Piper Aircraft Corporation
Vero Beach, Florida, U.S.A.

SERVICE *No. 860* BULLETIN

Main Landing Gear Downlock Cable
Anti-Rotation Stop Replacement

SKETCH "A"

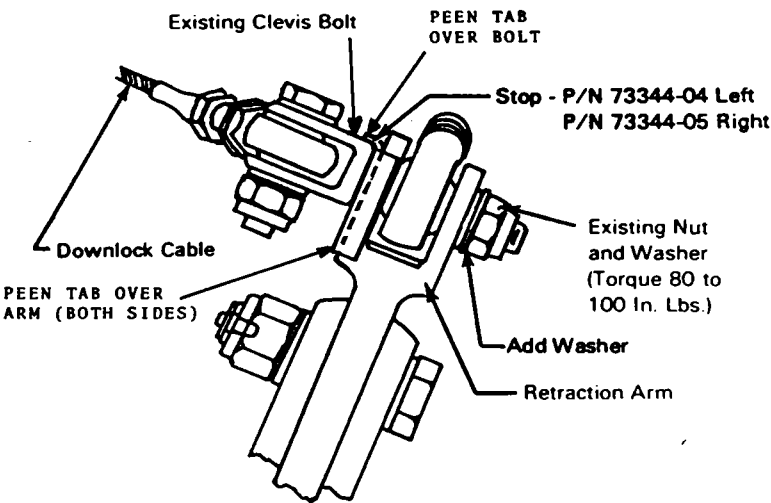
It has been determined that the existing anti-rotation stop used in conjunction with the main landing gear downlock cable, as installed on certain aircraft as a field retrofit or original factory installation, can allow the cable attach clevis bolt to rotate. This in effect shortens the length of the downlock cable, preventing full engagement of the downlock hook assembly. If this condition exists and is left uncorrected, a gear unsafe condition could occur.

This Service Bulletin announces the availability of an improved anti-rotation stop which, when installed, will prevent the above described condition.

1. Place aircraft on jacks.
 2. Remove nut and washer from the clevis bolt connecting the downlock cable to the retraction arm. Refer to Sketch "A" attached.
 3. Pull out the clevis bolt, remove and discard the existing anti-rotation stop.
 4. Install new anti-rotation stop, Piper Part Number 73344-04 (left gear) and 73344-05 (right gear), over the bolt and reinsert bolt through the retraction arm.
 5. Install an additional AN960-416 washer as well as existing washer and nut. Torque nut 80 to 100 inch pounds. See Sketch "A".
 6. Insure that tab on anti-rotation stop secures clevis bolt. See Sketch "A".
 7. Repeat procedure on opposite gear.
 8. Perform a gear function check.
 9. Remove aircraft from jacks.
 10. Make a logbook entry of compliance with PART I of this Service Bulletin.
-

1. Place aircraft on jacks.
2. Remove nut and washer from the clevis bolt connecting the downlock cable to the retraction arm. See Sketch "A" attached.
3. Pull out the clevis bolt, remove and discard the existing anti-rotation stop, if installed.
4. Install new anti-rotation stop, Piper Part Number 73344-04 (left gear) and 73344-05 (right gear) over the bolt and reinsert bolt through the retraction arm.

5. Install an additional AN960-416 washer as well as existing washer and nut. Torque nut 80 to 100 inch pounds. See Sketch "A".
 6. Insure that tab on anti-rotation stop secures clevis bolt. See Sketch "A".
 7. Repeat procedure on opposite gear.
 8. Perform a gear function check.
 9. Remove aircraft from jacks.
 10. Make a logbook entry of compliance with PART II of this Service Bulletin.
-
